NORTHWEST ENVIRONMENTAL DEFENSE CENTER
10015 S.W. Terwilliger Blvd., Portland, Oregon 97219
Phone: (503) 768-6673 Fax: (503) 768-6671
www.nedc.org

**RE: Comments on the Interstate 5 Columbia River Crossing Project
Removal-Fill Permit Application, No. APP0052419**

Figure 1: I-5 Bridge Traffic: Actual v. Predicted

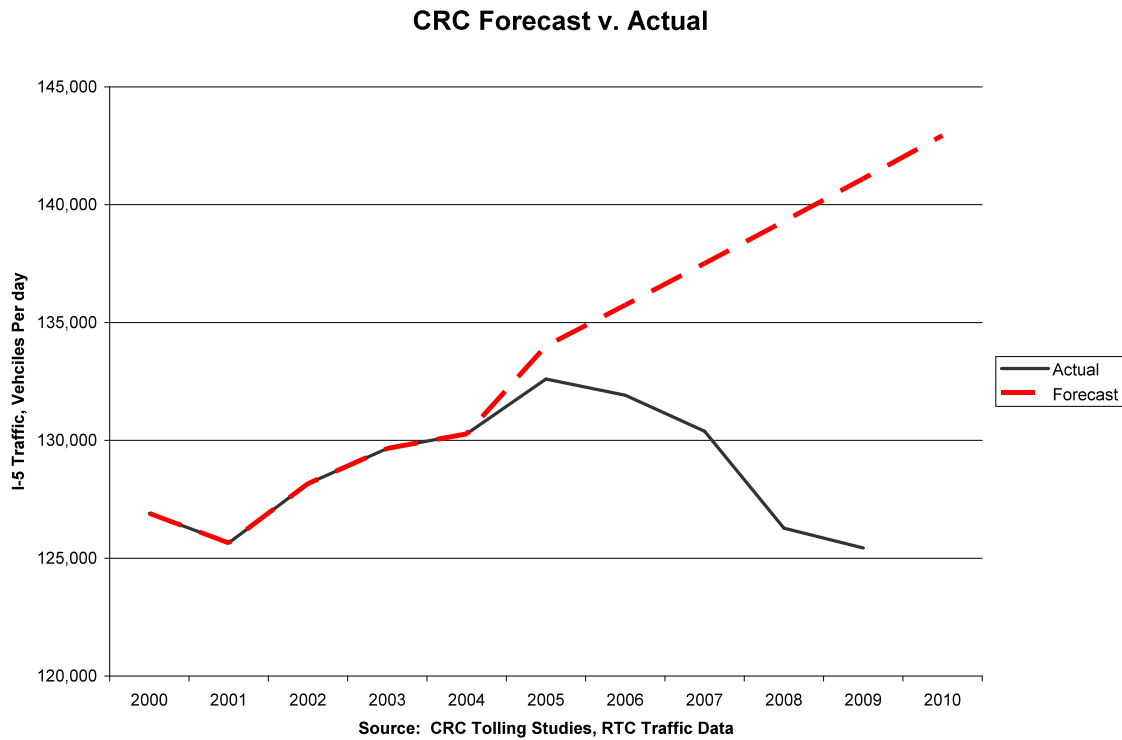
Figure 1 shows the actual level of traffic reported by the Regional Planning Council (from the table above), and the forecast level of traffic growth required to achieve the 2030 projection of 184,000 vehicles per day. The actual level of traffic recorded in 2009 was roughly 14,000

vehicles less than the more than 140,000 vehicles per day implied by the CRC traffic forecasts. Whereas the CRC forecast implied that traffic over the I-5 bridges (in the no build scenario) would increase by almost 7,000 vehicles per day; in reality, the number of vehicles crossing the bridge declined by 7,000.

Figure 2: National Trends in Vehicle Miles Traveled

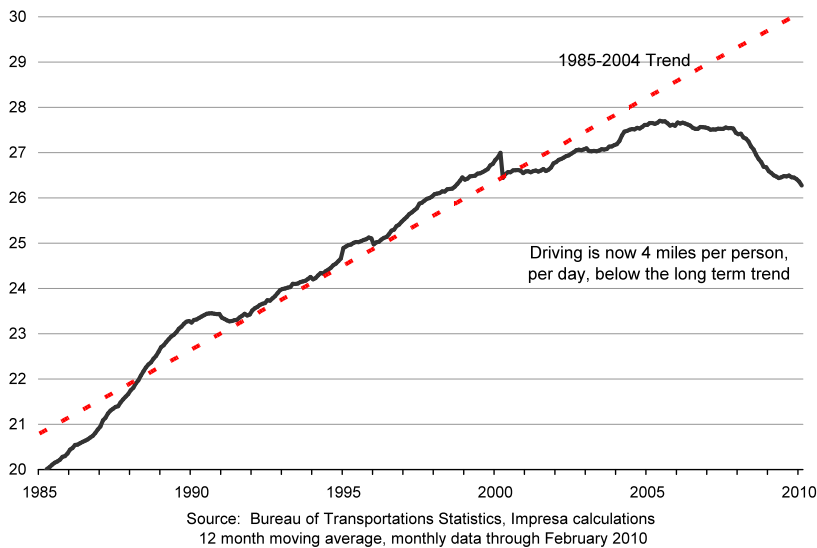
As Figure 2 makes clear, travel demand estimates based on pre-2005 trends are very likely to overestimate travel demand growth. Following the big increase in gas prices after 2004, American citizens began driving less. That trend has persisted over the past five years.
